**Subject: Beaver Valley Power Station, Unit No. 1
Docket No. 50-334, License No. DPR-66
License Amendment Request No. 292**

Pursuant to 10 CFR 50.90, FirstEnergy Nuclear Operating Company (FENOC) requests an amendment to the above license in the form of changes to the technical specifications. The proposed amendment would update the technical specification heatup and cooldown curves, and the overpressure protection setpoints and Bases to apply for up to 22 effective full power years (EFPY). The applicability for the current curves will expire at 16 EFPY. Therefore, approval of this license amendment is requested by February 1, 2002, to implement the amendment and allow continued operation beyond this time frame.

Beaver Valley Power Station, Unit No. 1
License Amendment Request No. 292

FIGURE B 3/4 4-2
EFFECT OF FLUENCE, COPPER CONTENT,
AND PHOSPHORUS CONTENT ON Δ RT_{NDT}
FOR REACTOR VESSEL STEELS PER REGULATORY GUIDE 1.99

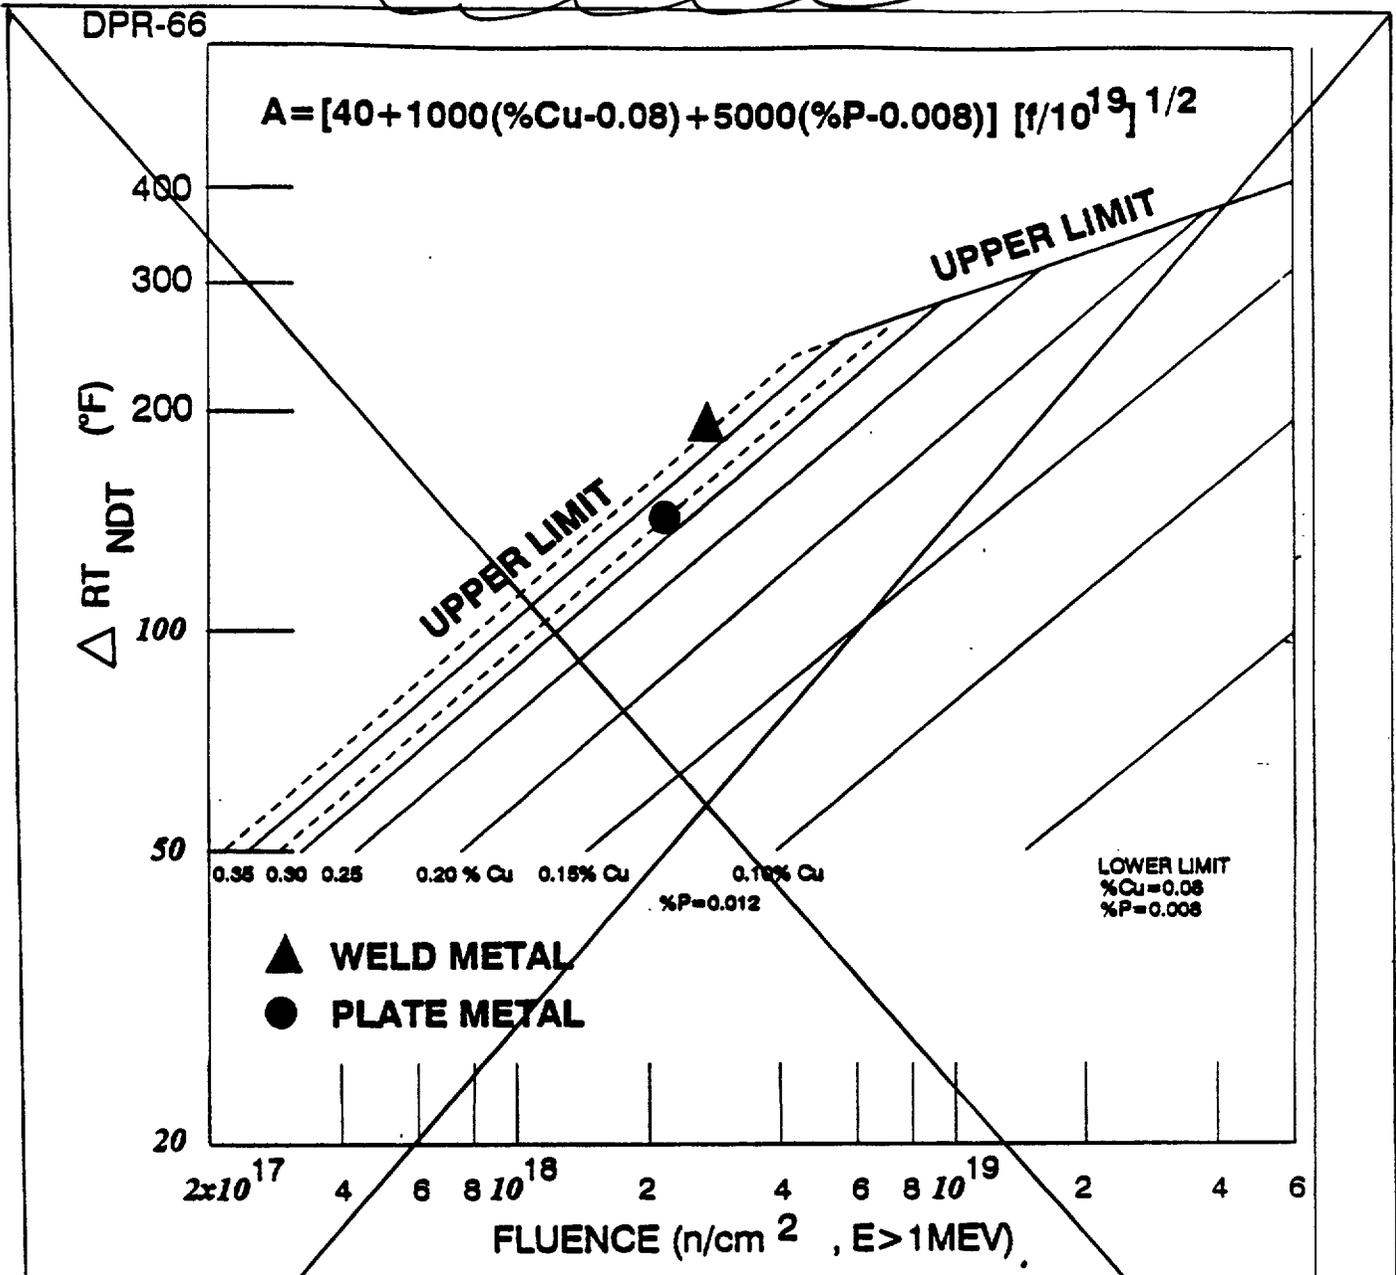
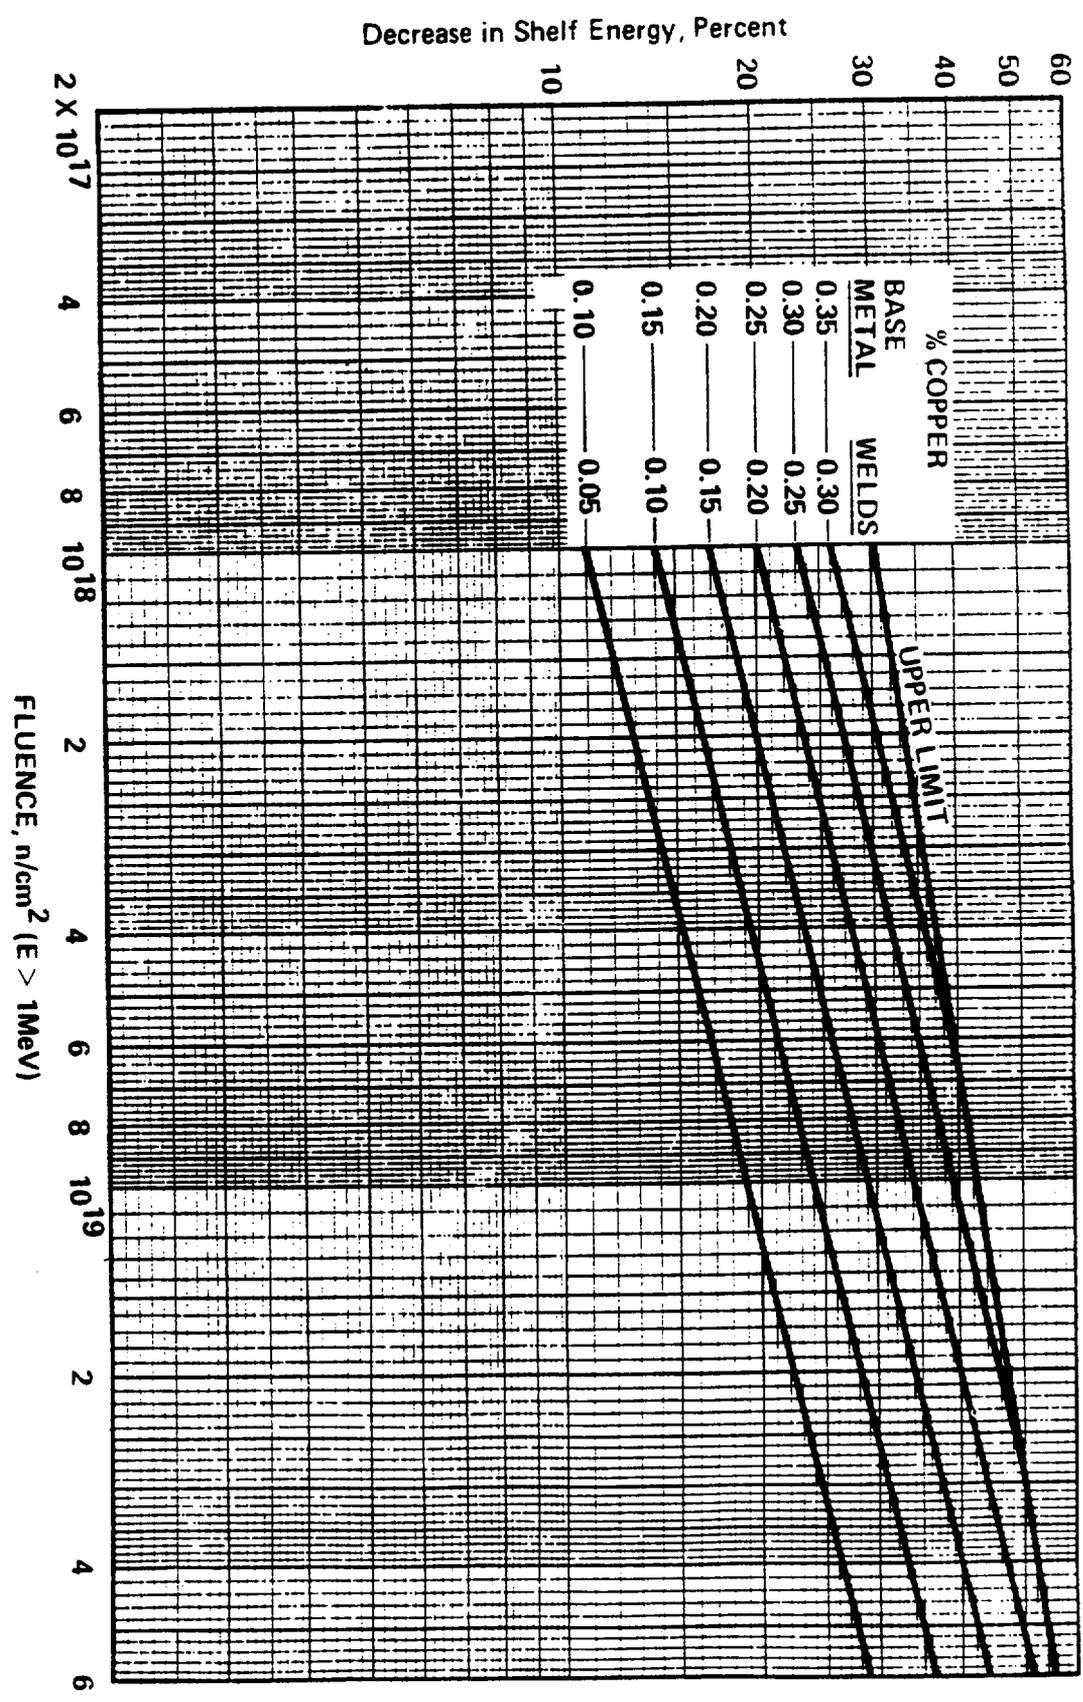
(Replace with Insect 1)

7. Figure B 3/4 4-2, "Effect of Fluence, Copper Content, and Phosphorus Content on ΔRT_{NDT} for Reactor Vessel Steels per Regulatory Guide 1.99," is replaced with a figure titled, "Predicted Decrease in Shelf Energy as a Function of Copper Content and Fluence." The figure replacement is being made because Regulatory Guide 1.99, Revision 2, uses the replacement figure to show the effect of fluence and copper content on upper shelf life for reactor vessel steel. The figure is also renumbered as B 3/4 4-1.

TEMPERATURE (°F)
FIGURE B 3/4 4-3 *2*

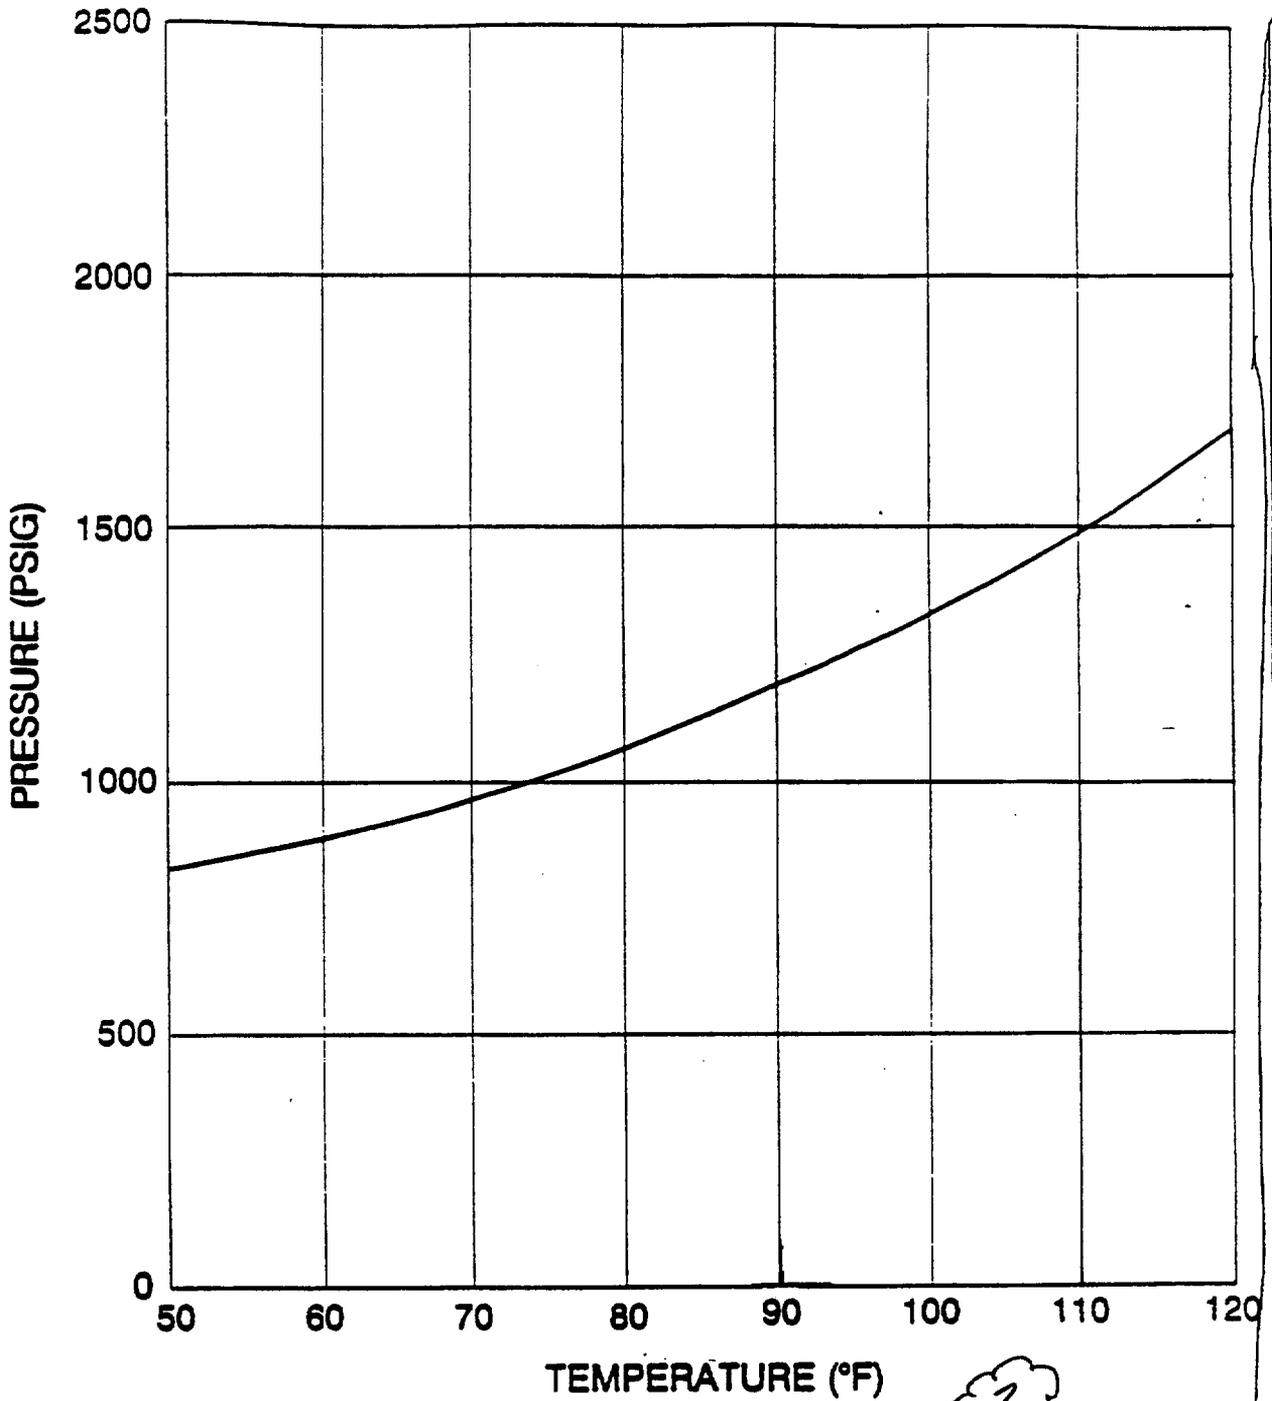
Pressure-temperature limit curves shown in Figure B 3/4 4-3 were developed for the limiting ferritic steel component within an isolated reactor coolant loop. The limiting component is the steam generator channel head to tubesheet region. This figure provides the ASME III, Appendix G limiting curve which is used to define operational bounds, such that when operating with an isolated loop the analyzed pressure-temperature limits are known. The temperature range provided bounds the expected operating range for an isolated loop. *AND ASME Code CASE N-640*

8. Table B 3/4.4-1, "Reactor Vessel Toughness Data (Unirradiated)," is updated to be consistent with the revised heatup and cooldown curves.
9. Figure B 3/4 4-3, "Isolated Loop Pressure-Temperature Limit Curve," is renumbered as B 3/4 4-2.
